From: **Ashwin Muralidharan** Date: **30 Jul. 19** File No: S25504\148\H-121\ca190730s0017 Pages: 2
Project: **Qantas Flight Training & Simulator Centre (Tender No. 9760)** No: **H-004[1.0]**

Hydraulics – Response to Comments on SSDA Submission

This Consultant Advice provides NDY's comments to Agency and stakeholder submissions received during the public exhibition of the SSD 10154 for the development of a new flight training centre at 297 King Street, Mascot.

<small>This drawing is for information purposes only.</small>				
Project: QANTAS FLIGHT TRAINING FACILITY				
Title: SYDNEY WATER BUILDING PLAN APPROVAL				
Document Number: RH-010-A				
Project No: S25504-148	Drawn: -	Date: 26/7/19	Scale: NTS	Rev: 1.0

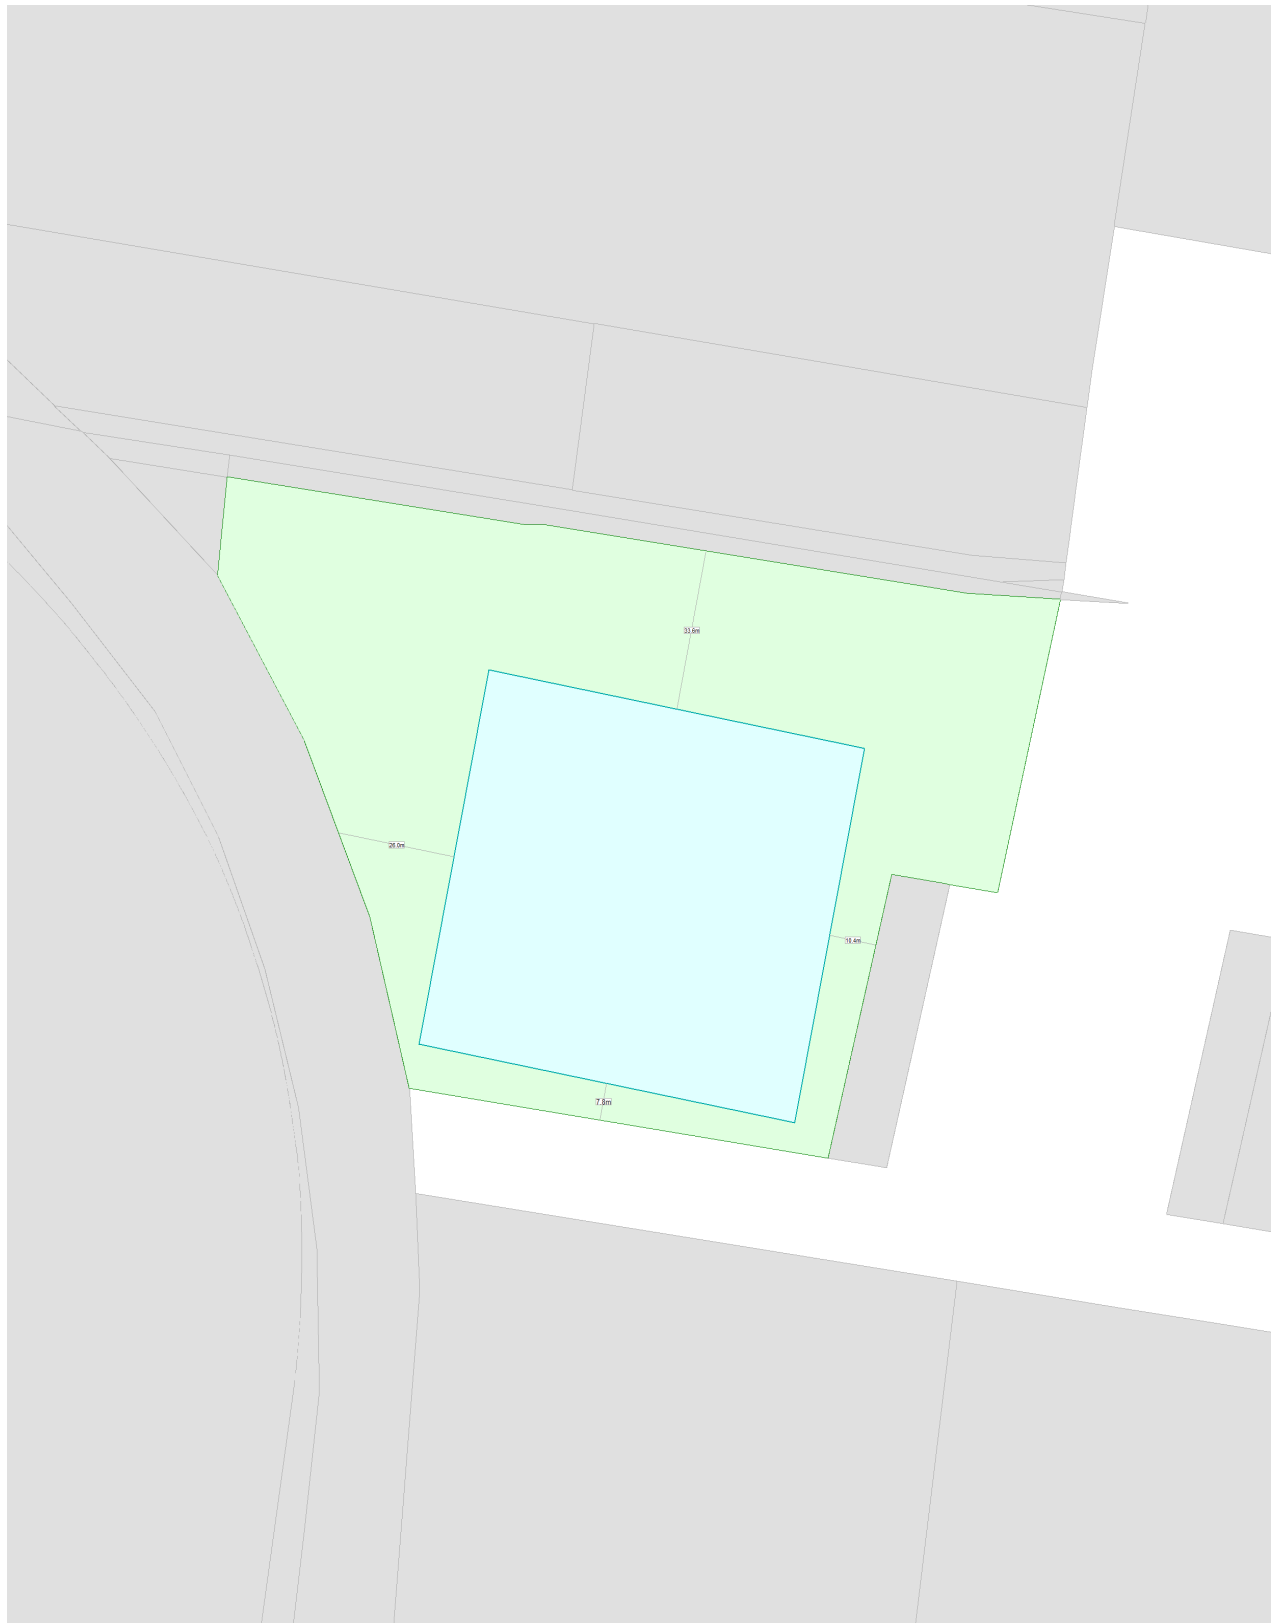
Building over or adjacent to stormwater assets:

- *Sydney Water's guidelines for building over or adjacent to stormwater assets outline the process and design requirements for such activities. As per the guidelines, the applicant is advised of the following: * No building or permanent structure is to be proposed over the stormwater channel /pipe or within 1 m from the outside wall of the stormwater asset or within Sydney Water easement whichever is larger. Permanent structures include (but are not limited to) basement car park, hanging balcony, roof eaves, hanging stairs, stormwater pits, stormwater pipes, elevated driveway, basement access or similar structures. This clearance requirement would apply for unlimited depth and height. * The applicant is required to submit the elevation drawings with the stormwater channel/pipe, to ensure that the proposed buildings and permanent structures are 1 m away from the outside face of the stormwater channel and away from the Sydney Water easement. Please refer to the relevant guidelines for further detail on requirements and the process for approval.*

We understand this relates to Sydney Water Building Plan Approval. During the initial design phase, NDY had lodged the building plan approval with Sydney Water via the tap-in portal and have received approval for the same. This application is to ensure that there are no buildings over or adjacent to any Sydney Water asset. Please find attached building plan approval (RH-010-A).
